# UNITED STATES PATENT AND TRADEMARK OFFICE

APPLICATION NO.	FILING DATE	FIRST NAMED INVENTOR	ATTORNEY DOCKET NO.	CONFIRMATION NO.
10/511,861	02/08/2005	Stan Nowak	ASEFF.0101	6378

## Office Action Summary

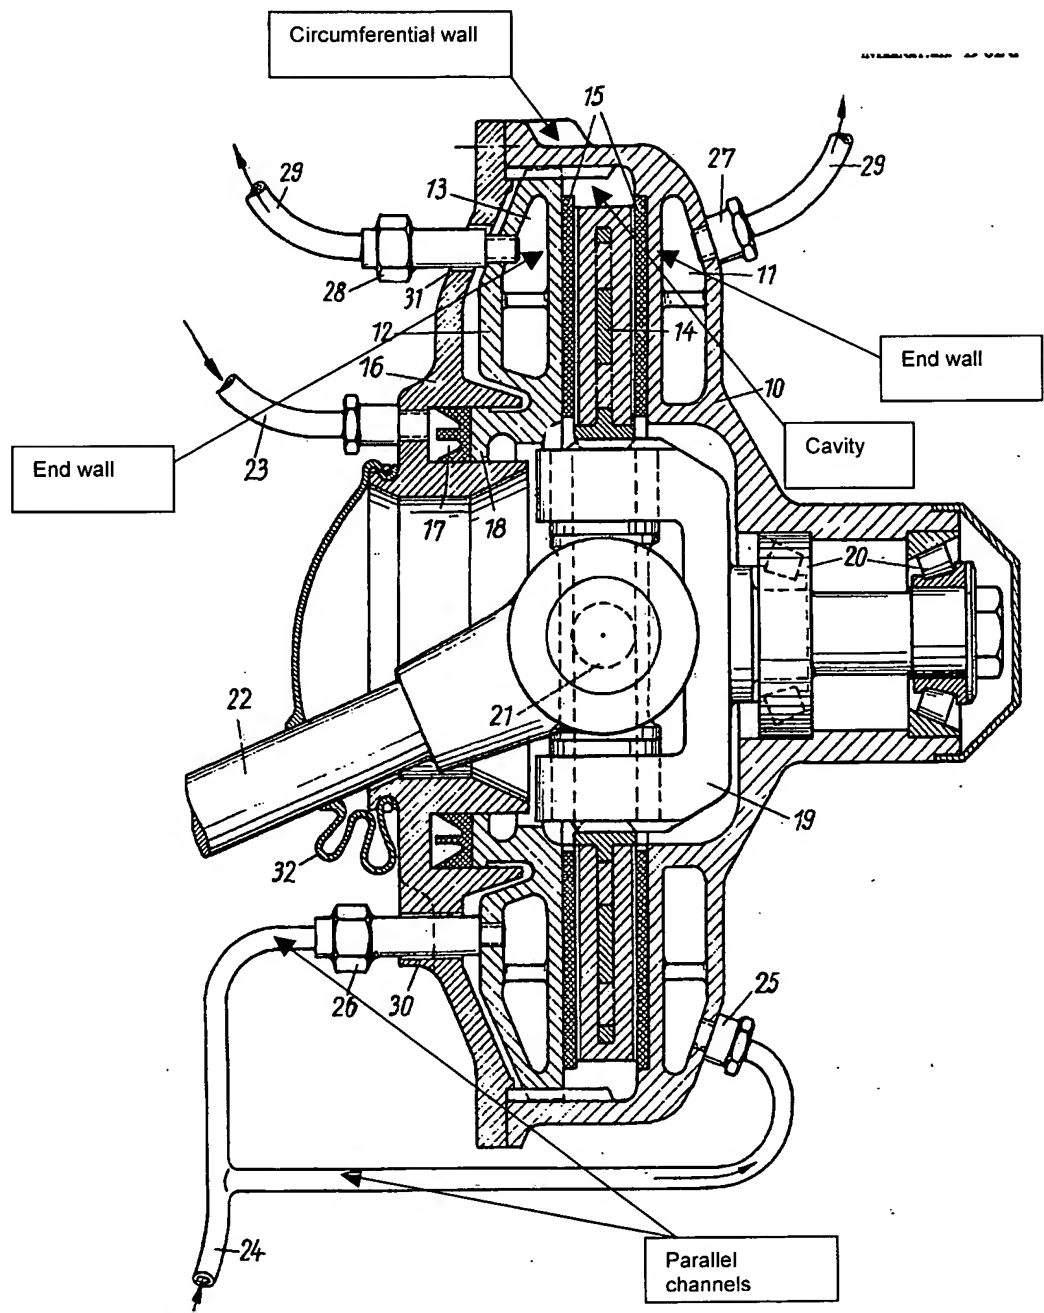
Re: claims 1-3, 15, 16, and 20. DE'319 shows in the figure a fluid cooled brake housing 10 for a brake system that includes friction pads 15 and a rotatable element 14 to be braked, the brake housing comprising a circumferential wall as labeled and two axial end walls as labeled that define a cavity as labeled for housing the friction pads and rotatable element, an opening in the at least one of the axial end walls shown surrounding element 19 through which a portion of the rotatable element can extend, a fluid flow path 13 formed around the periphery (the inner periphery) of the circumferential wall such that the fluid flow path is external to the defined cavity as shown, a fluid inlet 24 in fluid communication with the fluid flow path, a fluid outlet 29 in fluid communication with the fluid flow path, a supply of cooling fluid connected to element 24 in fluid communication with the fluid inlet and the fluid outlet, the cooling fluid flowing from the fluid inlet through the fluid flow path to the fluid outlet thereby cooling the entire brake housing, and a seal means 17,32 for sealing the opening such

Re: claim 11. DE'319 shows the housing comprising a volume of lubricating fluid or fluid surrounding element 19 sealed within the cavity and at least partially covering the rotatable element and the lubricating fluid separate from the cooling fluid by virtue of the structure surrounding element 13.

Re: claim 17. DE'319 shows in the figure the limitation wherein the fluid flow path includes a plurality of parallel channels as labeled in the annotated figure on pg. 3 of the instant Office action extending between the fluid inlet and the fluid outlet.

Applicant argues that DE'319 does not anticipate claim 1 because it fails to include the fluid flow path "in the circumferential wall external to the cavity of the housing" as discussed in lines 9-10 of pg. 11 of the Remarks. Examiner notes that the argument is more specific than the claim language. Examiner notes that claim 1 does not require that the fluid flow path be "in the circumferential wall." Instead, claim 1 requires that the fluid flow path be "formed around the periphery of the circumferential wall." Examiner notes that the fluid flow path 13 of DE'319 accommodated in an annular jacket is formed around the periphery and, particularly, the inner periphery of the circumferential wall labeled on pg. 3 of the Office action. Examiner notes that the

Examiner further notes that the bottom surface of the circumferential wall may be considered as one of the outward bounds of the wall. The fluid path 13 being annular in configuration extends along the entire inner periphery of the circumferential wall.

Therefore, Examiner maintains that the fluid flow path is formed around the periphery of the circumferential wall. With regards to the fluid flow path being external to the cavity, Examiner maintains that the cavity has been redefined as set forth in the annotated drawing on pg. 3. In light of the newly interpreted location of the cavity, it is apparent that the fluid flow path is external to the cavity.

Applicant then argues that DE'319 does not anticipate claim 1 or claim 20 because it does not show a seal means for sealing the opening of the cavity in order to create a wet brake system. Examiner notes that the opening is shown surrounding element 19. Elements 17 and 32 clearly seal or block the passage of fluid from and into the area surrounding element 19. The claim recites the wet brake limitation in functional terms. Since the seal means 17,32 blocks fluid passage, Examiner maintains that the seal means of DE'319 is capable of sealing such that the cavity can be partially filled with lubricating fluid to provide a wet brake housing. Examiner also notes that the argument that since the prior art of DE'319 teaches the use of a wet brake system, it is doubtful that DE'319 would seek to teach a similar wet brake is not persuasive. First, Applicant's doubt that DE'319 would not teach a wet brake is purely speculative. Second, it does not matter whether DE'319 actually teaches a wet brake since claim 1 merely requires that the seal means be capable of sealing to provide a wet brake.
